A G E N D A
FARRAGUT MUNICIPAL PLANNING COMMISSION

November 20, 2014
7:00 p.m. Farragut Town Hall

SUBJECT: Discussion and public hearing on a concept plan for the Farragut Apartments, Parcels 108 and 109, Tax Map 130, 820 N. Campbell Station Road, 31.94 Acres (GBS Engineering, Applicant)

**SUBJECT: STAFF COMMENTS ON THE CONCEPT PLAN FOR THE
FARRAGUT APARTMENTS, PARCELS 108 AND 109, TAX MAP
130**

CONCEPTUAL SITE PLAN
Scale: 1" = 60'-0"

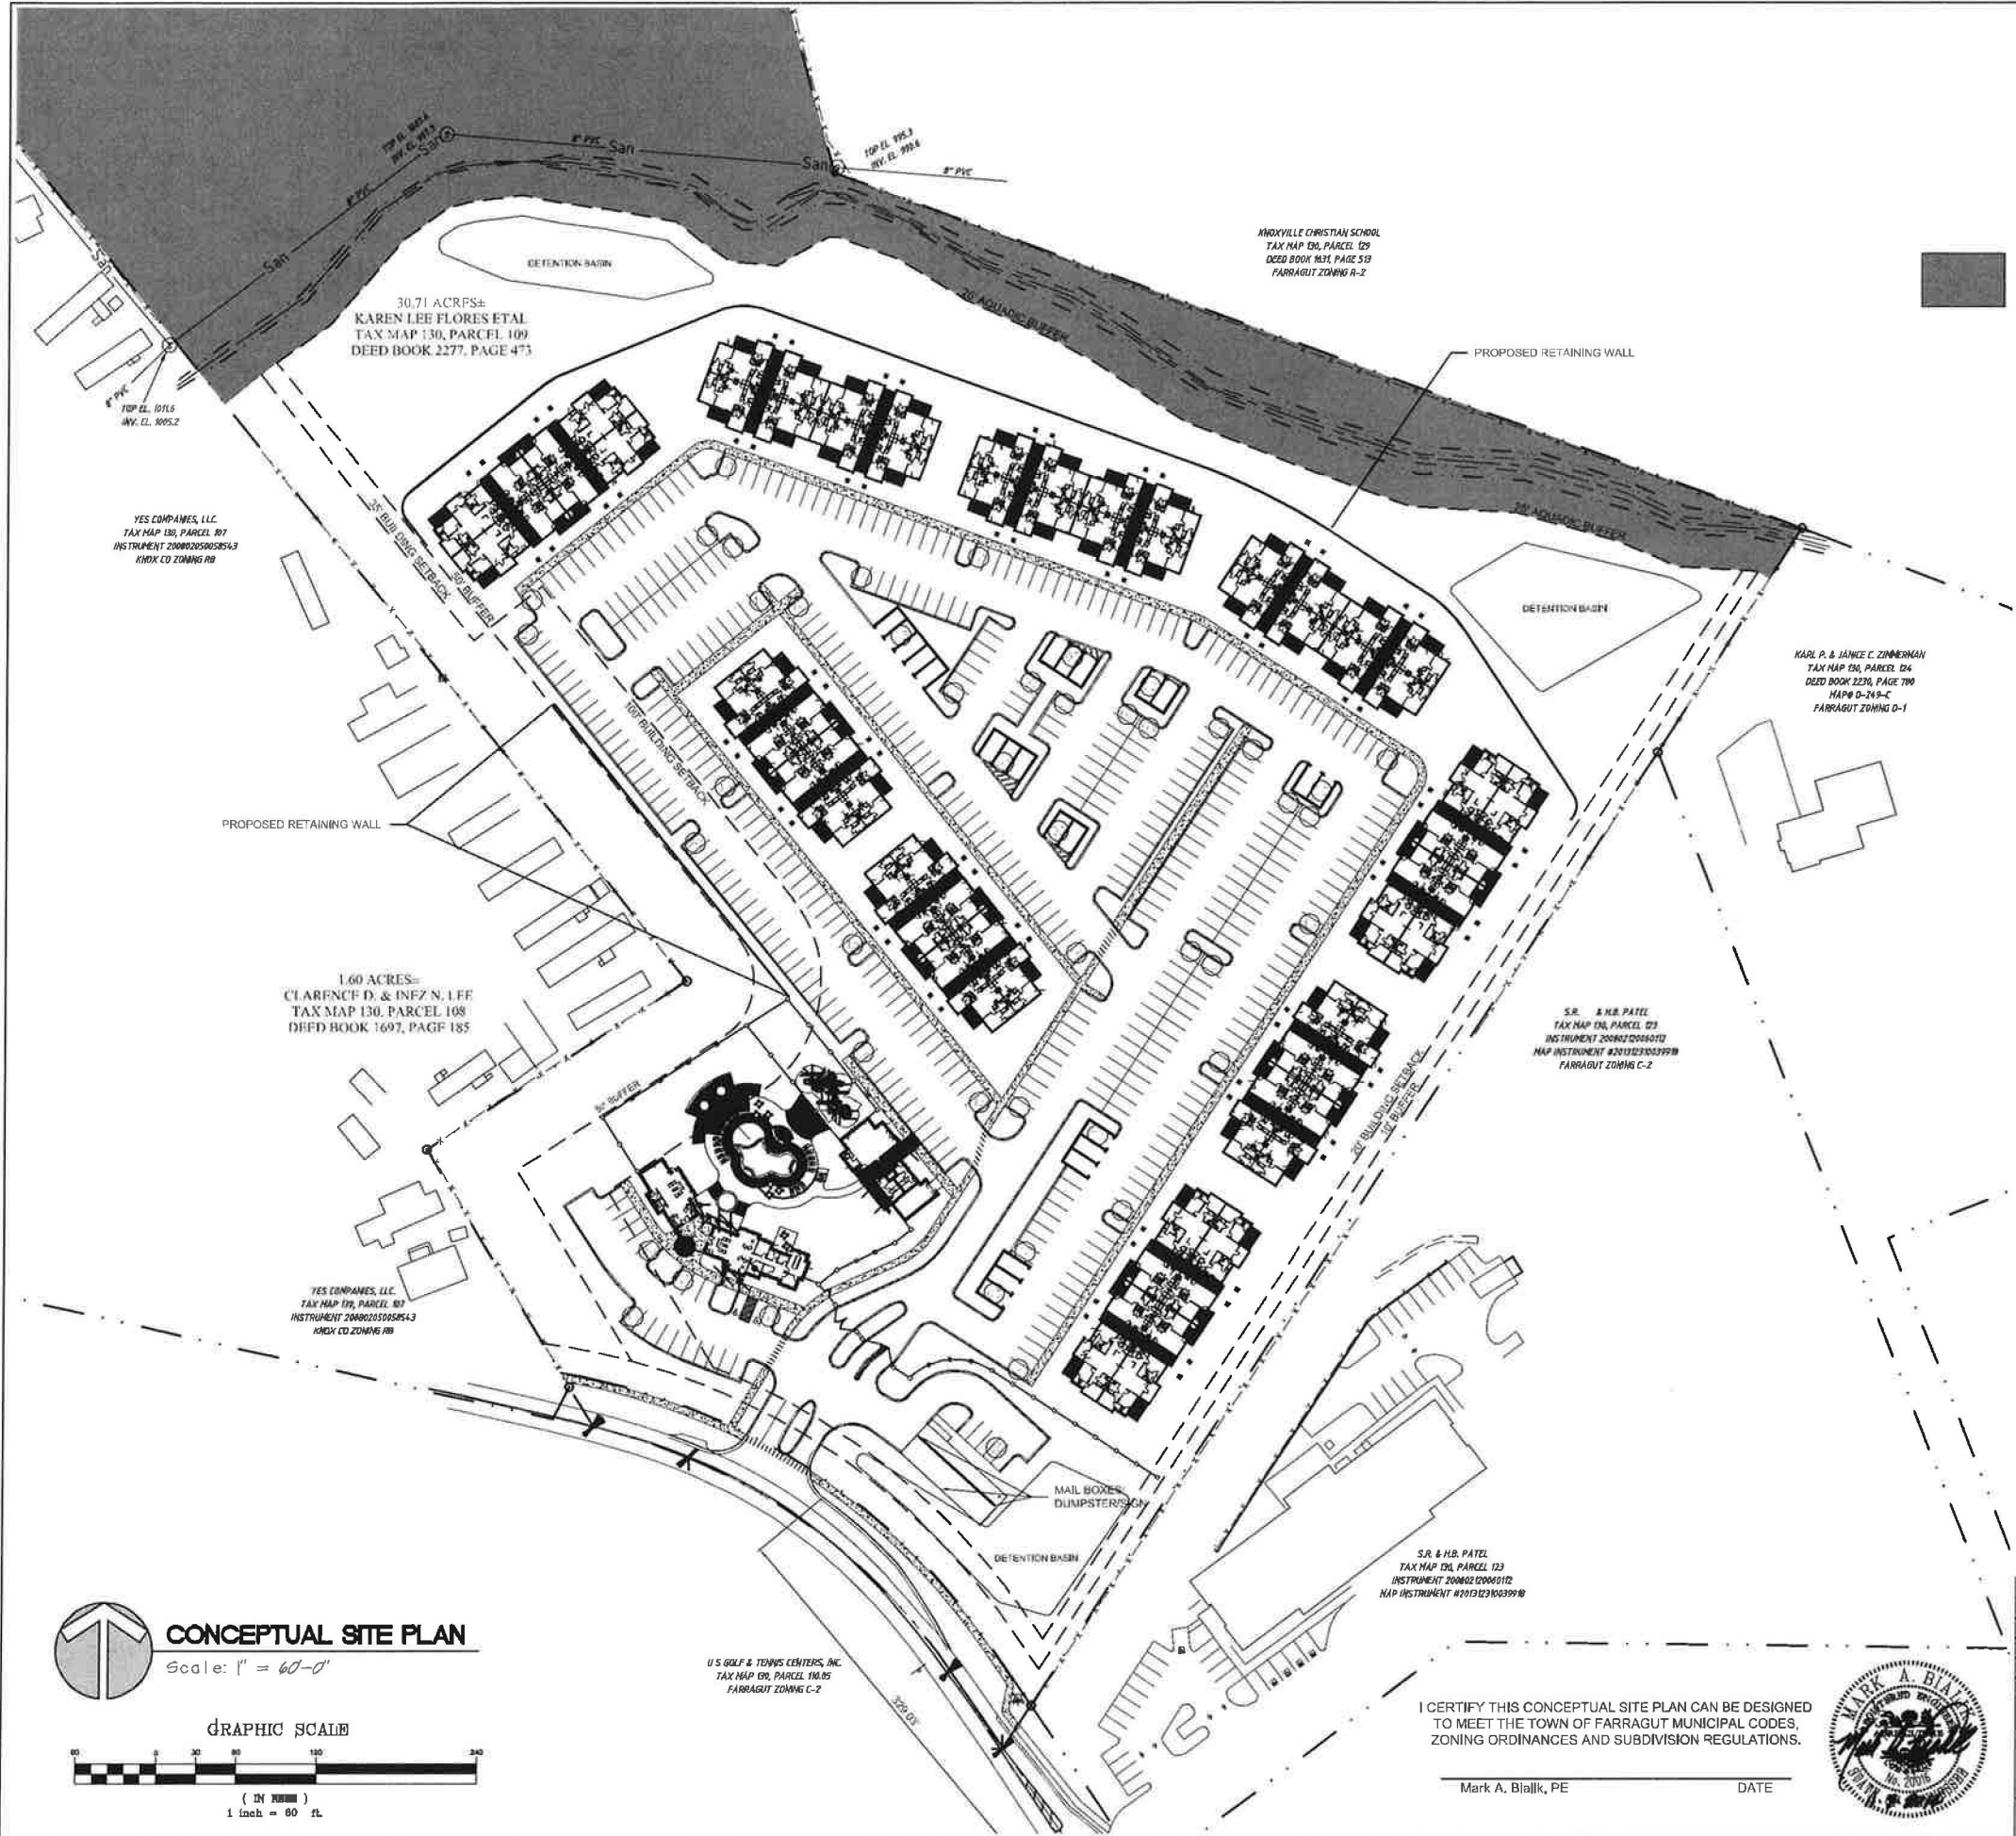
- 1) Provide a project name on the drawings.
- 2) An additional, remotely located, fire apparatus access road is required in accordance with D106.2 of the 2012 International Fire Code.

- 3) In the title block please indicate that this plan contains conceptual information which is not intended for construction purposes;
- 4) Please include on the plan the name, address, and contact information for the owner and developer;
- 5) Please include professional seal of the principal individual responsible for preparing the plan;

- 6) Please include the present (and in this case pending) zoning classification on the land involved in this development and on the adjoining land;
- 7) Per the OSMFR Overlay, please show the entire property and the area that is being designated to satisfy the 50% common open space. Open space containing natural features worthy of preservation (e.g. in this case, steep slopes, streams, woodlands, any possibly any known springs or sinkholes) must be left unimproved and undisturbed;

- 8) Related to the previous comment, some adjustments will need to be made to the concept plan to avoid some very steep areas where currently stormwater detention and other grade work is proposed. How stormwater detention is being addressed must be discussed. The staff would recommend using the parking lot (with bioswales in islands, more frequent and linear shaped detention areas and rain gardens, and some sections of permeable pavers for storage with the basic idea of dispersing runoff to numerous locations so as to avoid construction of large detention basins that cannot (by ordinance or by function) be constructed on the slopes where some of these are currently proposed;

- 9) Please provide a pedestrian connection from the parking lot to the sidewalk along N. Campbell Station Road;
- 10) Where more than 15 parking spaces are in a row the interior parking lot islands must be at least 10 feet in width;

- 12) Please show the limits of disturbance on the property relative to the required buffer strip areas;
- 13) Please note that ultimately a subdivision plat will be required for this property to combine Parcels 108 and 109 and plat the common open space (staff would recommend platting the common open space as its own recorded lot and referencing it as an exhibit in a covenant that runs with the land and that is also recorded at the Register of Deeds) and any applicable easements, etc. The right of way will be 40 feet from the centerline of N. Campbell Station Road. Please adjust the layout to address this. Also, per the TIS, the access was recommended on the north end of the property unless it can be demonstrated that good sight distance is provided at the location proposed;

- 18) Are the small squares adjacent to each building proposed lights?
- 19) Please include a note on the plan which identifies those utilities that are readily available and are expected to serve the site;

BAD DADDY'S BURGER BAR

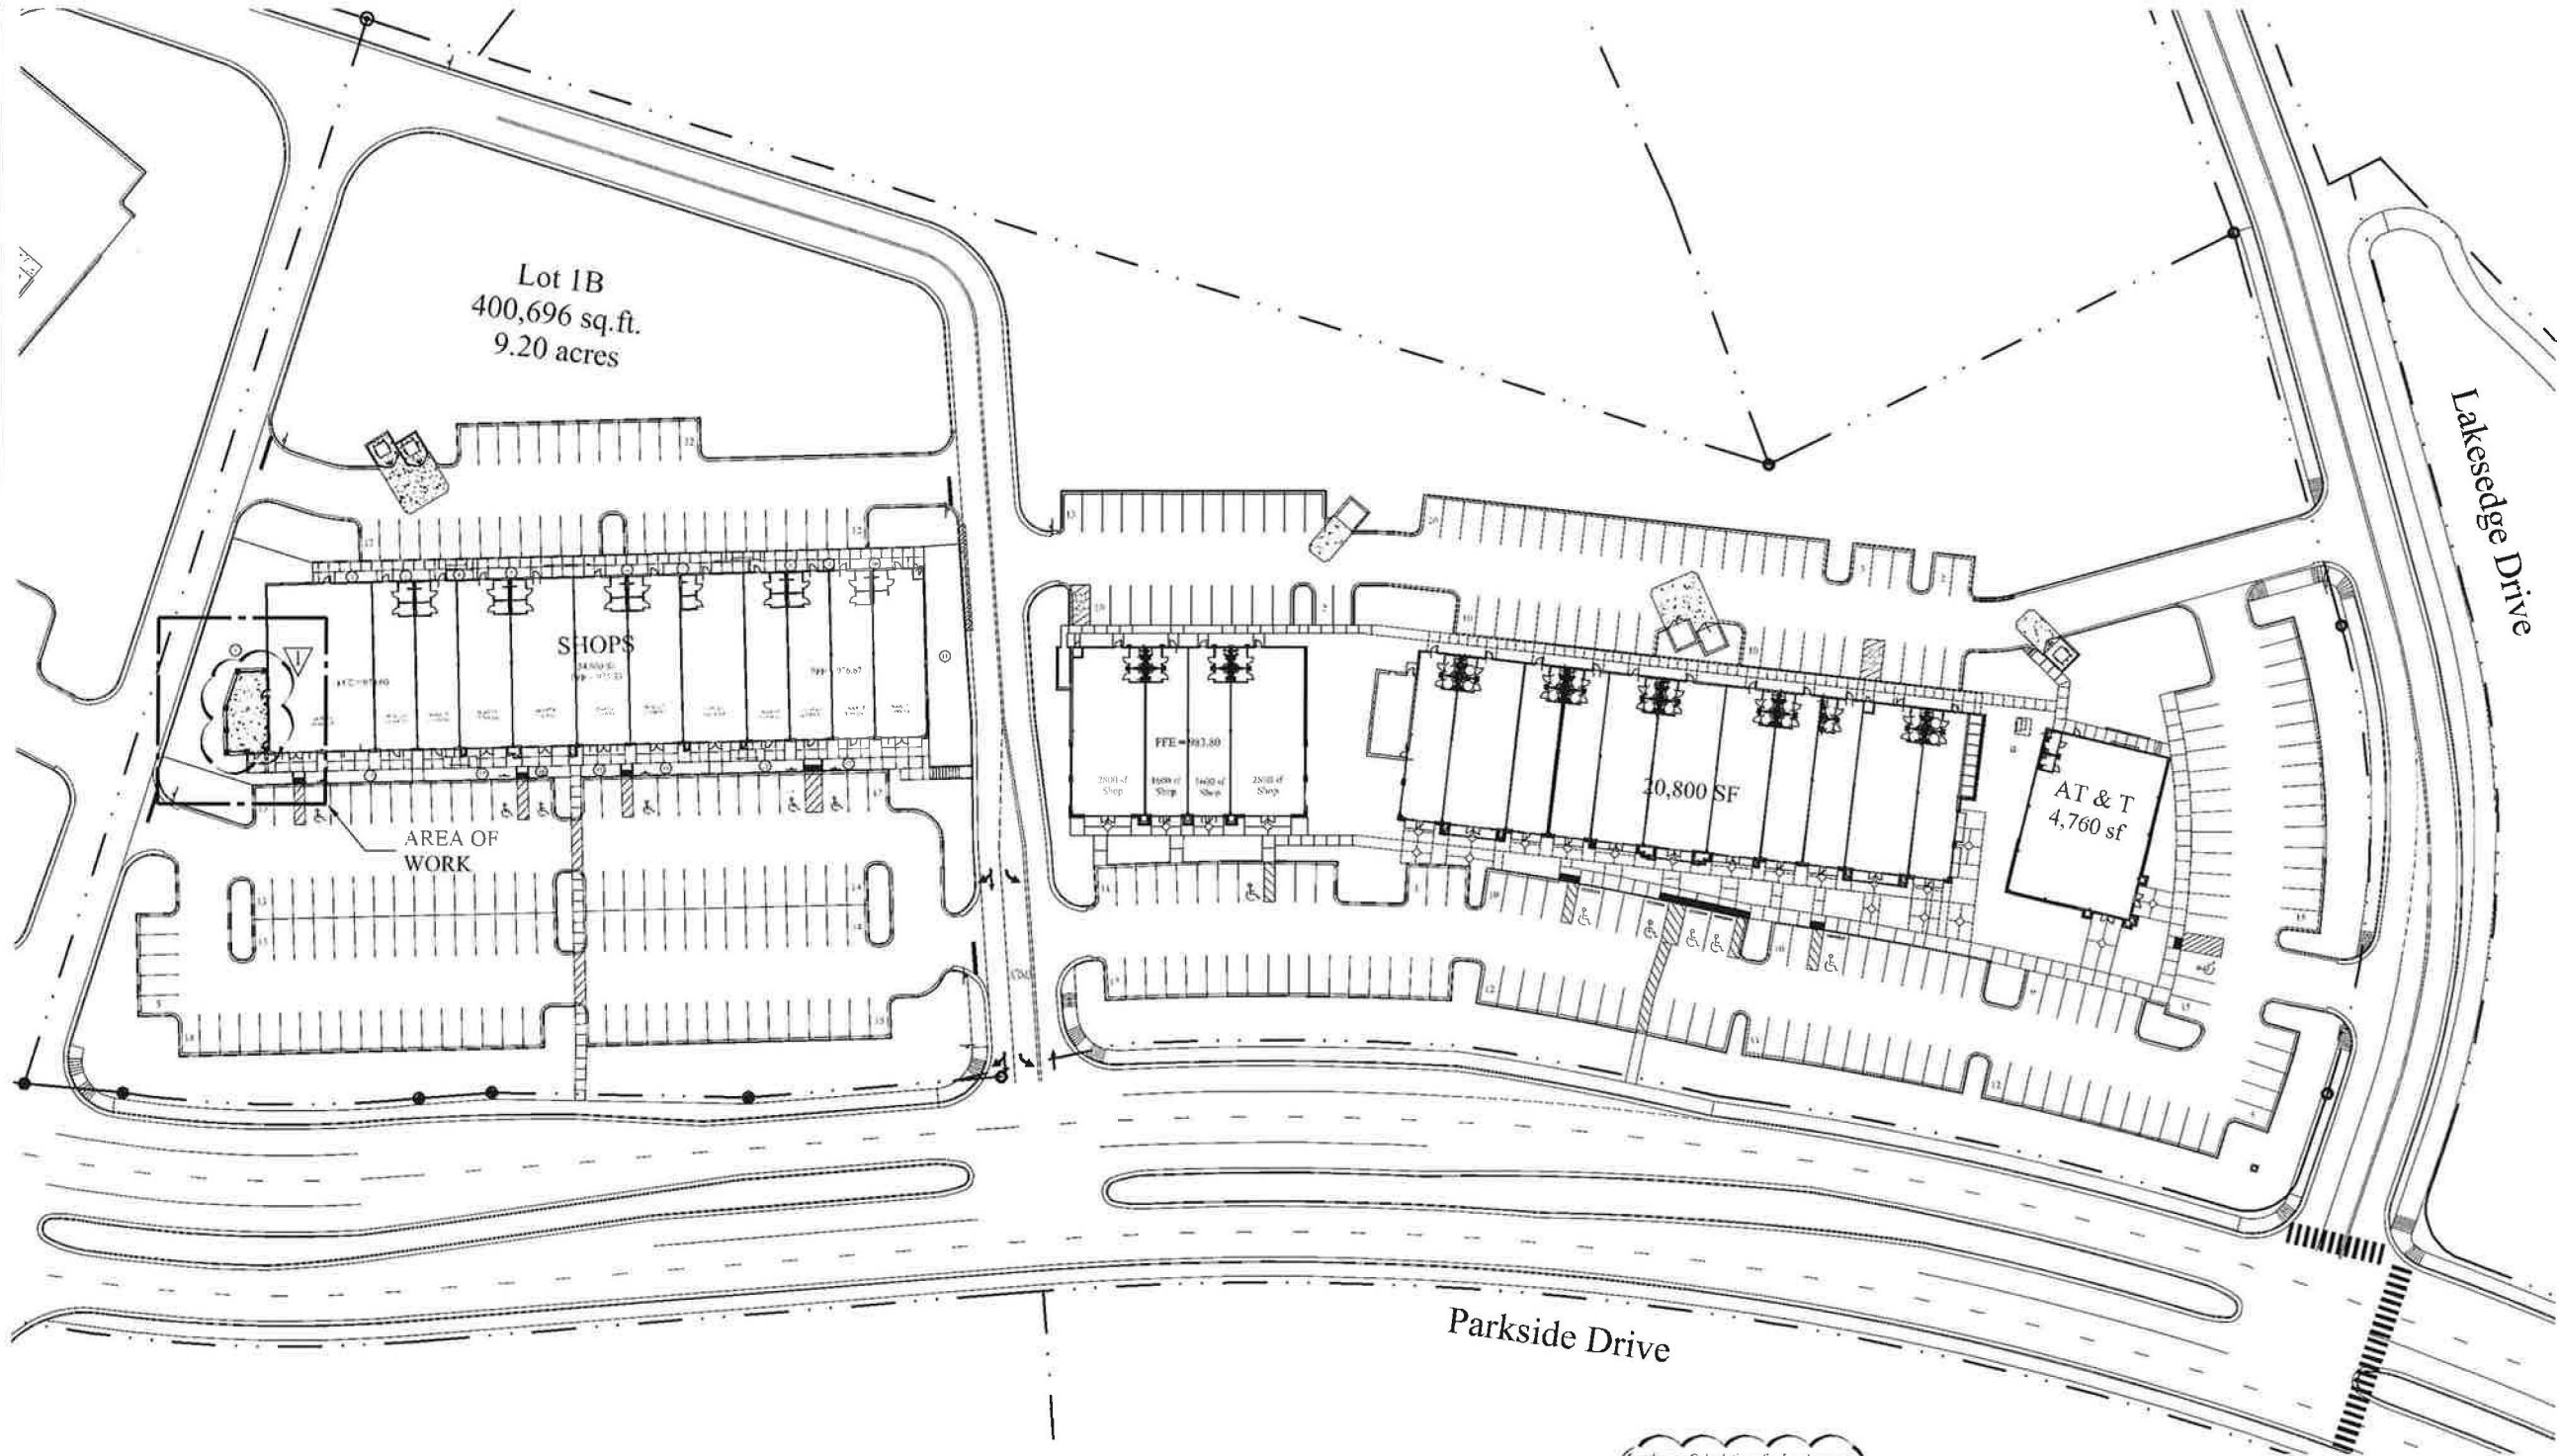
- 1) Please provide a detail of the egress gate and latch for the patio gate. A detail is referenced, but could not be located on the submitted drawing;
- 2) Please provide the required fire sprinkler and fire alarm protection under the new roof system. This can be addressed on the building submittal;

- 3) Please add a note to the plans that no additional lighting will be added as part of this project;
- 4) How is the slope being addressed in the northwest corner?
- 5) Please include silt and tree protection fencing on the plans and include a detail for each;

- 6) The minimum side setback in C-2 is 35 feet with a total of 80 feet on the two sides. It appears some modifications will be needed to comply with these required setbacks; and
- 7) Please identify species of trees and shrubs to be protected.
